PRODUCT AWARENESS BULLETIN

FROM ROSENBAUER

BULLETIN NUMBER: 6010

QUOTE WRITER NUMBER: 50-06-1110
(3-SIDED); 50-06-1100 (2-SIDED)

DESCRIPTION: Turntable Shape - Three Sided

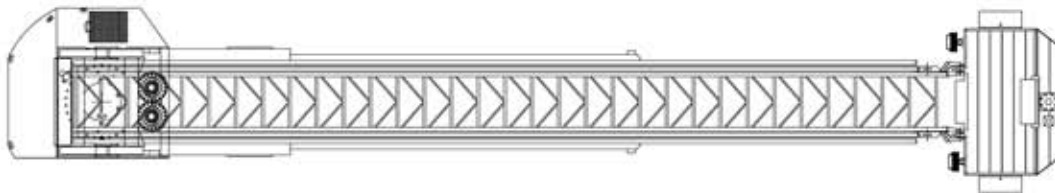
SPECIFICATION: The turntable shall be three sided (left, rear & right) with the corners cut to allow for personnel to enter and exit the turntable. The turntable walking area shall be covered with NFPA #1901 compliant skid resistant aluminum tread plate material, with a 2-1/2" lip. Three 42" high, slip resistant handrails capable of withstanding a 225 pound force applied from any direction shall be installed on the turntable.

DESCRIPTION: Turntable Shape - Two Sided

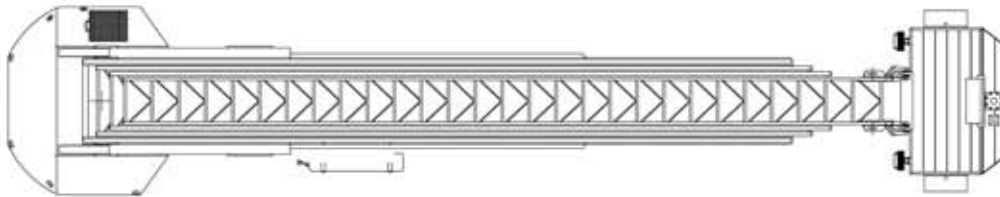
SPECIFICATION: The turntable shall be two sided (left and rear) with the corners cut to allow for personnel to enter and exit the turntable. The turntable walking area shall be covered with NFPA #1901 compliant skid resistant aluminum tread plate material, with a 2-1/2" lip. Two 42" high, slip resistant handrails capable of withstanding a 225 pound force applied from any direction shall be installed on the turntable.
